**STAFF RECOMMENDATION**

**818 Shelby Avenue**

**December 20, 2017**

**Application:** New construction – infill and outbuilding

**1 SITE PLAN**  
 A-1 1" = 30'-0"

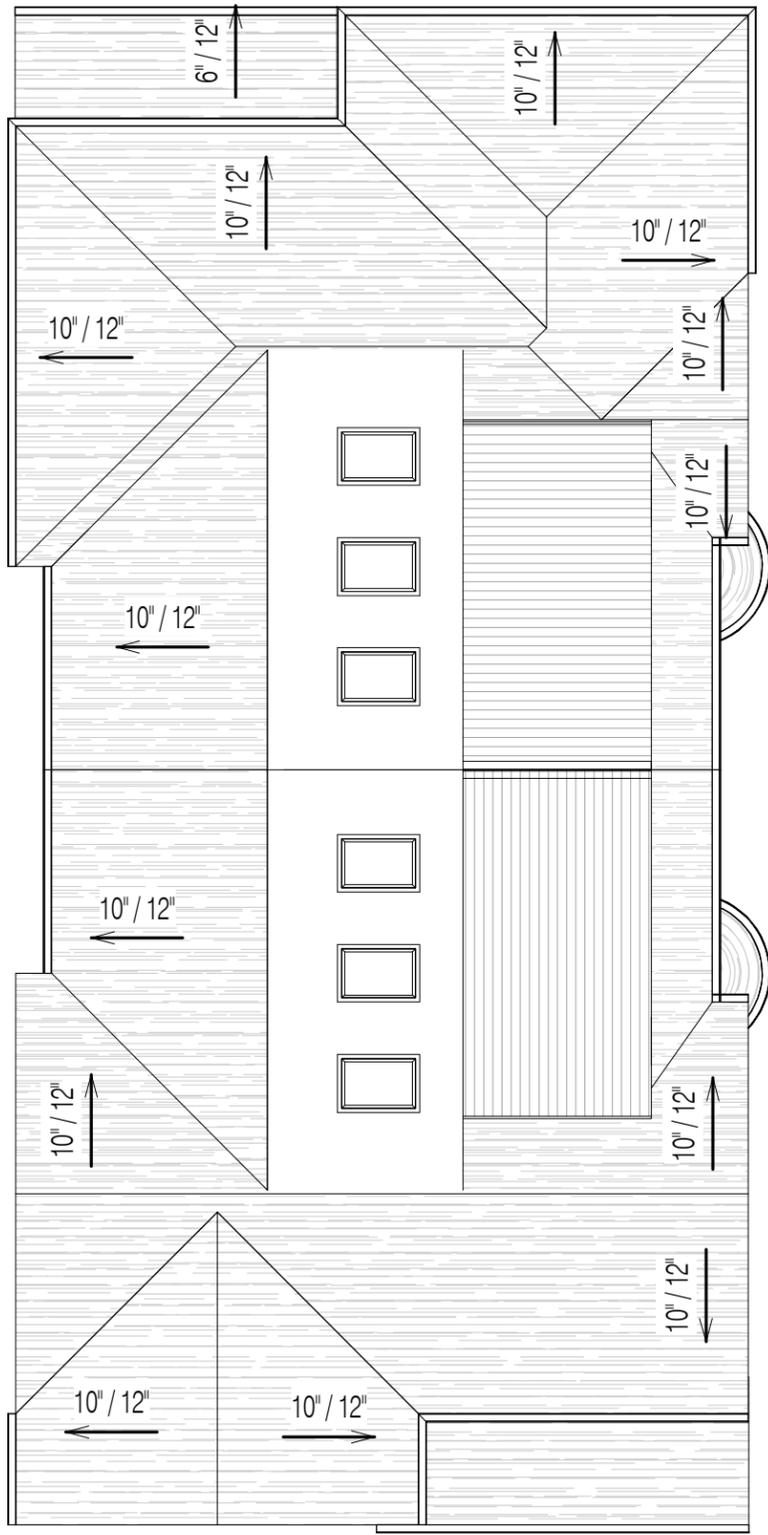
Appurtenances & Utilities: The site plan does not show a walkway connecting the front porch to the street, as is typical of houses in the area historically, nor are there any walkways for the rear unit or driveways shown. The location of the HVAC and other utilities was also not noted. No other appurtenance including fences, retaining walls, lighting, and other permanent landscape features have been indicated. Staff recommends as a condition of approval that these items be included on a revised site plan prior to beginning construction, as they must all be reviewed for compatibility under section III.B.2.i of the Edgefield Historic Preservation Zoning Overlay design guidelines.

- The third-level roof decks is eliminated from the plan; and
- Brick color, siding texture and reveal, roof color, and all the window and door selections shall be approved by MHZC Staff prior to construction; and
- A paved walkway shall be added connecting the front porch and the sidewalk; and
- Permanent landscape features including walkways, driveways, fences and retaining walls, lighting, and any other appurtenances shall be approved by MHZC Staff prior to installation; and
- The HVAC condenser shall be located behind the midpoint of the building on a non-street-facing elevation.

**3 ROOF**  
A-2 1" = 10'-0"

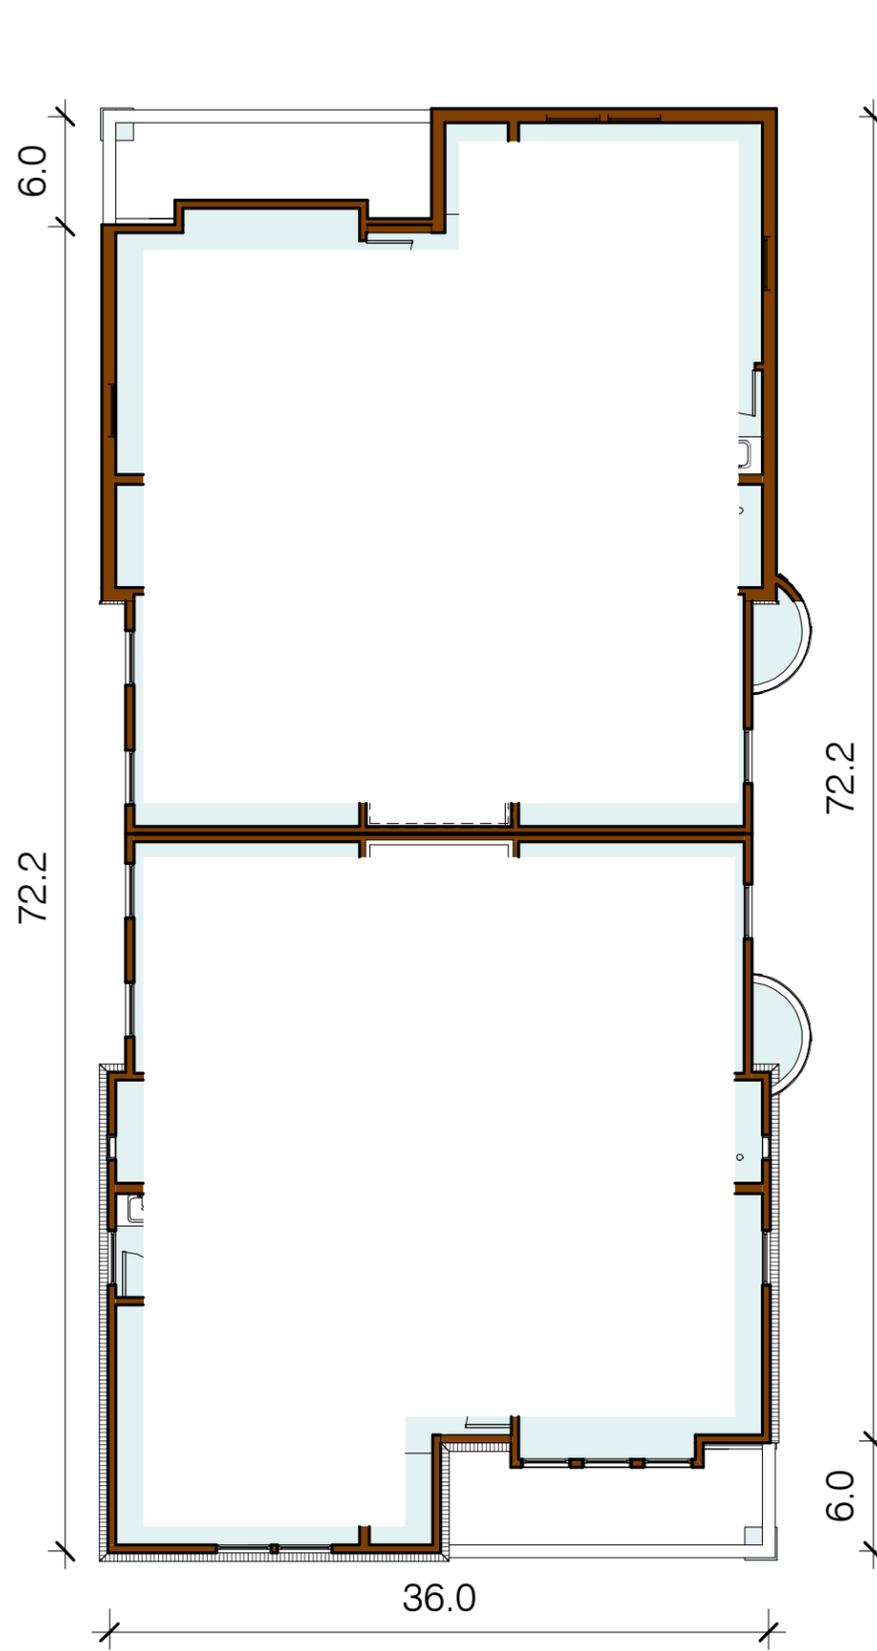
A portion of the center section of the roof on the right side will be flat and partially recessed to create a third level deck. Roof level decks are not typical of historic houses in the neighborhood. With the condition that the roof deck is eliminated, Staff finds that the project is compatible with surrounding houses and finds that the project will meet sections III.B.2.c and III.B.2.d of the design guidelines.
